# Scour Calculations Review Illustrated

By Raymond Morgan, PE

1. Arizona Administrative Code guidelines on the design of sewer lines across floodways.
2. Definition of a floodway
3. Review of pressure sewer design crossing a floodway
4. Review of vertical scour calculations of washes that the pressure sewer crosses.
5. Review of horizontal bank erosion potential calculations of washes that the pressure sewer crosses.
6. Review of the design report statements
7. Review of the soils report that the design report uses to justify the tractive force calculations for potential bank erosion
8. Review of ADWR Watercourse System for Sediment Balance

# Revised Design at Station 32+00

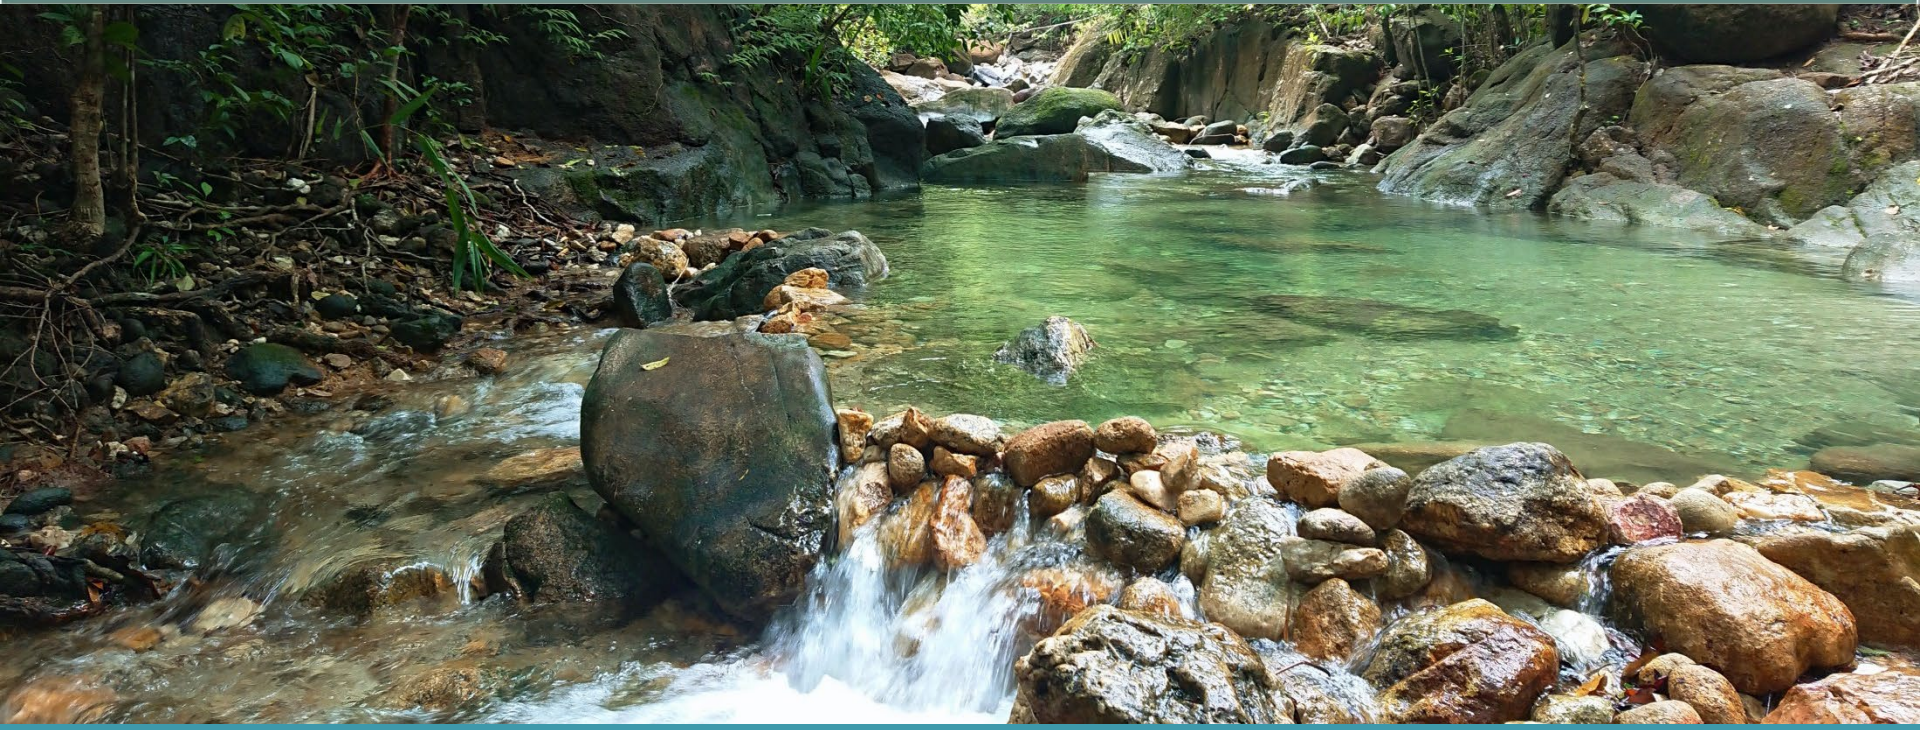
1. The Arizona Administrative Code (AAC) requires the following issues to be addressed:
  - a. 100-year scour depth
  - b. 100-year bed degradation
  - c. 100-year lateral migration (aka scour) of the drainageway banks
2. The AAC does not specify the specific method to do these calculations.
3. Therefore, the designer can choose the calculation method but they must follow that method fully and consistently.
4. The designer should show the calculation formulas, provide the reference to the calculation procedure and provide the results of the calculations. If the calculation procedure is not readily available on the internet, they should provide a copy of that procedure to the agency reviewer.

5. The statements in the design report cannot be relied upon at face value. They need to be confirmed in the calculations and associated reference documents.
6. Is the design consistent with the calculations and associated reference documents?
7. Does the design work to protect the infrastructure from 100-year storm events?
8. Is the design governed by facts or assumptions? A design based upon assumptions is directly related to those assumptions. If the assumption is flawed, then the design will be flawed. To put this thought another way – a conclusion is no better than the assumptions it is founded upon.
